June 29, 2023

### **URGENT: Lever- and Gear-operated Pool-Pro™ and Type-57P Butterfly Valve Manufacturing Issue Notification**

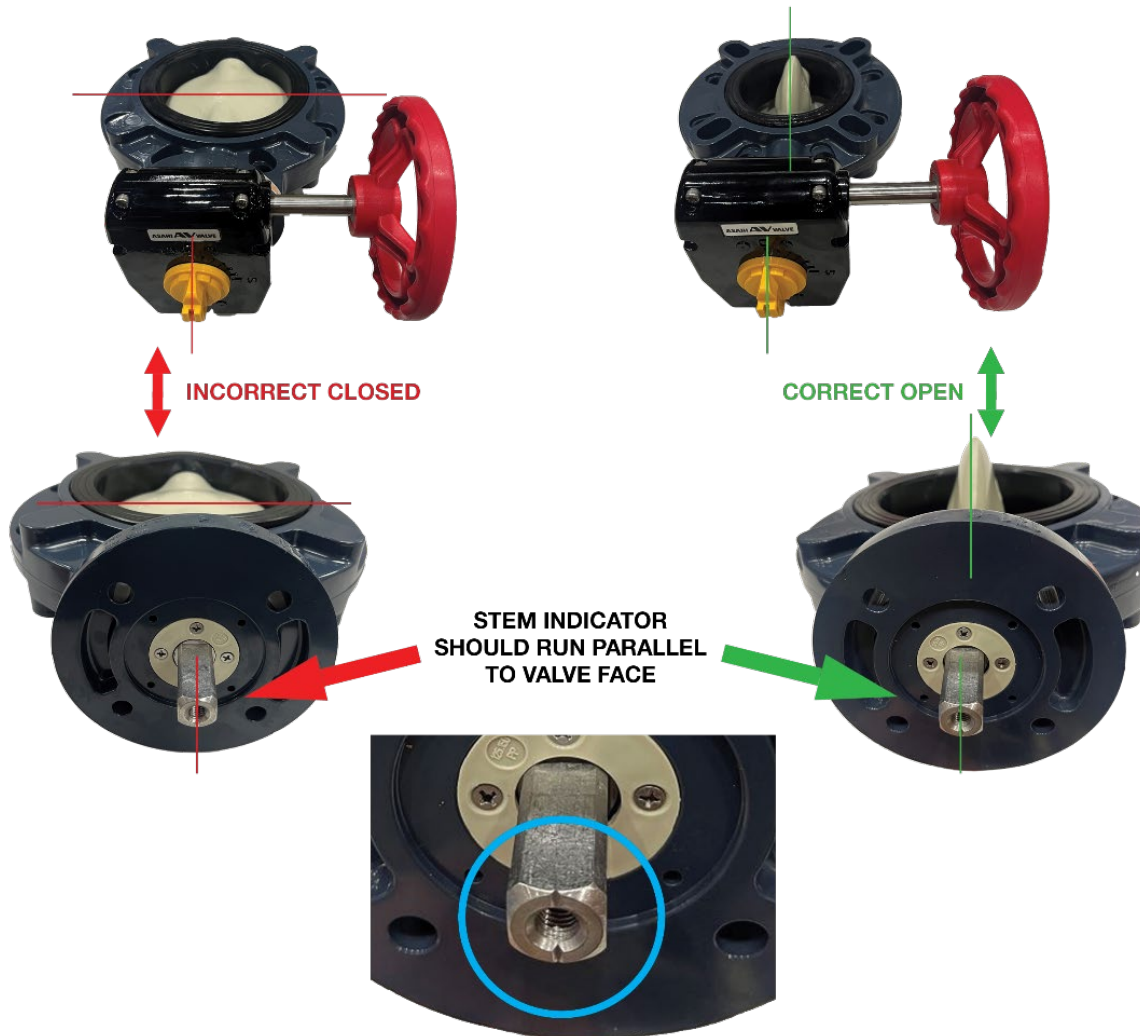
We have recently become aware that during the assembly process for some of these valves, the stem may have been improperly installed and were not detected in final QC inspection. In some cases, the stem was installed into the disc incorrectly whereby the open/close indicator on the stem was incorrectly aligned to the relative position of the disc within the body of the valve, i.e. rotated 90 degrees that would result in improper indication to the position of the disc.

In no way is the operation of the valve affected by the positioning of the stem; the valves will operate as designed and intended. The valves will perform to our pressure/temperature tables in O&M manuals. Upon installation, valve handles need to be installed in the field showing proper orientation to the disc. Gear operators are factory installed and the yellow visual indicator vs. disc orientation should be checked prior to installation (See photo below). It is when (if) the handle, gearbox or actuators are removed from the body after installation whereby the indicator marks on the stem may be false. When the valve is closed, the handle will be perpendicular to pipe line. When the valve is open, the handle will be in-line with the pipe line.

To quickly and easily identify, use the following methods:

- Lever: Inspect valve by removing the Lever, if necessary, and then match the disc position with the line indicator on the stem of the valve
- Gear: Inspect the gear operator indicator to match the disc position  
(Please see pictures below for your reference)

**DO NOT DISASSEMBLE VALVE**
